Service Bulletin No. 351

<i>MODEL</i>	D Series Coaches	<i>TYPE</i>	Field Change Program	<i>SECTION/GROUP</i>	6 – Cooling	<i>DATE</i>	
<i>SUBJECT</i>	MISSING WELDS ON FAN BELT IDLER PULLEY COVER						
<i>CONDITIONS</i>

Ref. NHTSA Recall No.: 11V–TBD

Figure 2.

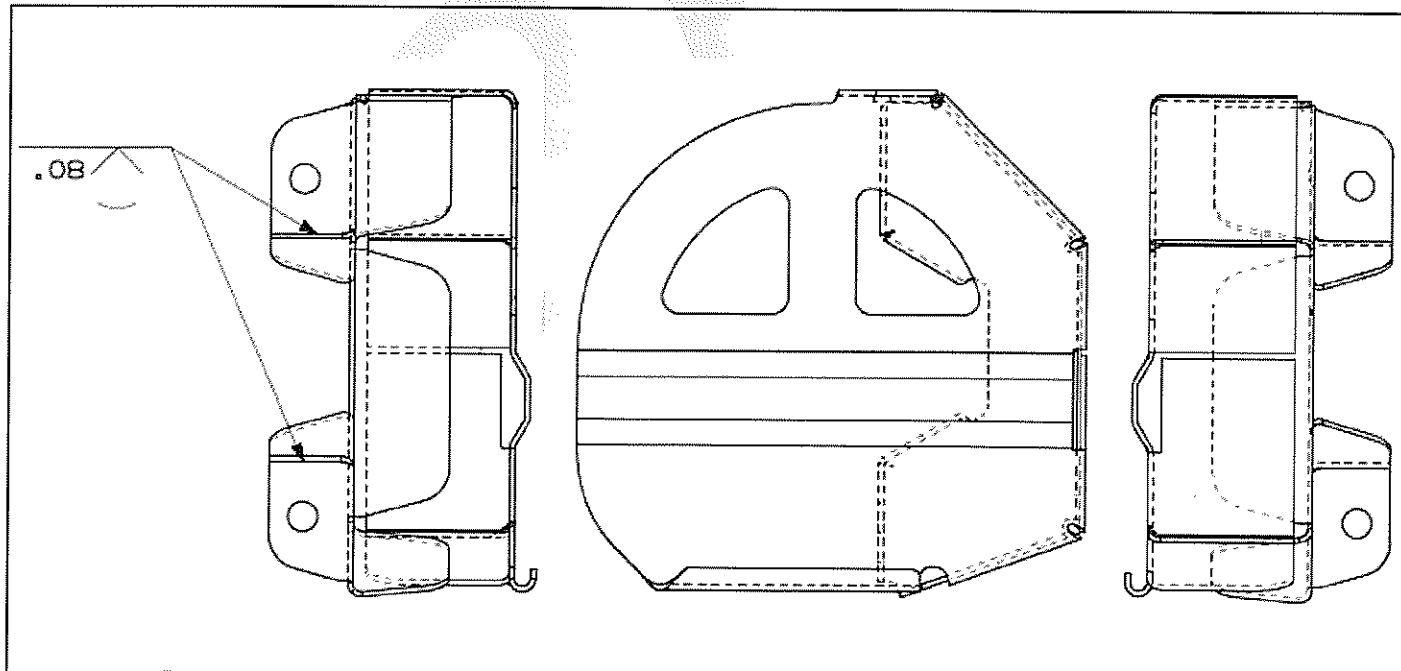
MCI has determined that the fan belt idler pulley cover may lack two welds that provide stiffness and rigidity to the part. Without these welds MCI believes that the part will eventually fail as a result of fatigue near the area where the cover is assembled to the coach structure. If a failure of both attachment areas occurs, the part may become detached from the coach and potential injury to persons and/or damage to other vehicles or property could occur.

4. Visually inspect the fan belt idler pulley cover for the two (2) welds shown in Figure 2

If the two (2) welds shown in Figure 2 are on the fan belt idler pulley cover, no further action is required. Close the engine door. Fill out the attached verification form and submit to MCI's warranty department.

If the two (2) welds shown in Figure 2 are not on the fan belt idler pulley cover, proceed to Step 5.

Figure 3.

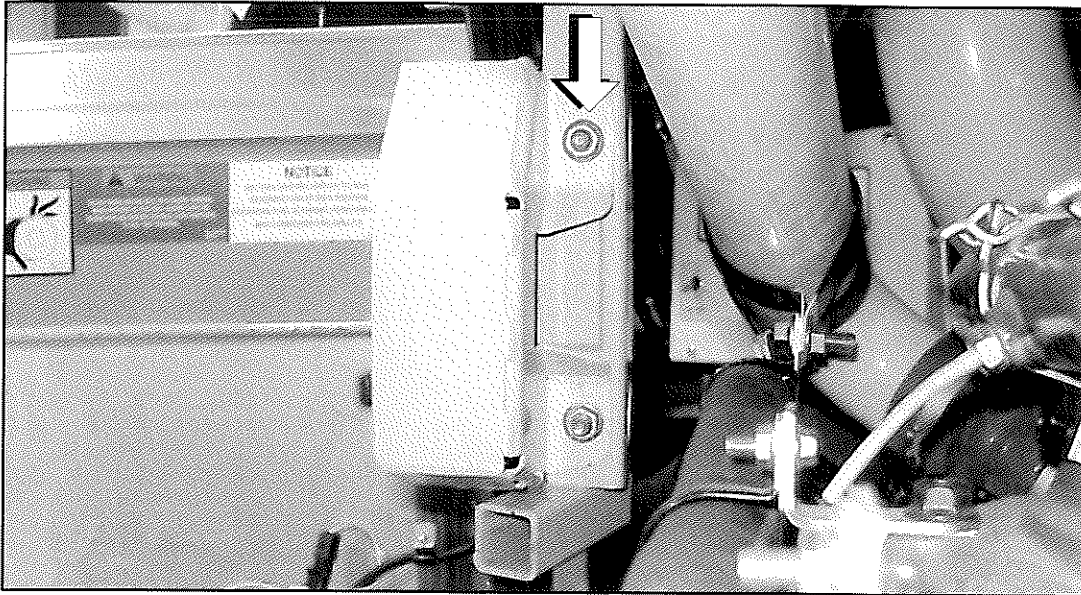
5. Remove and retain the idler pulley cover mounting hardware (refer to Figure 3). Discard the existing idler pulley cover.
6. Using the existing mounting hardware, install the new idler pulley cover, p/n 06-06-1629.
7. Torque to 43–47 ft.-lbs. Apply torque seal from the face of the capscrew to the face of the cover.
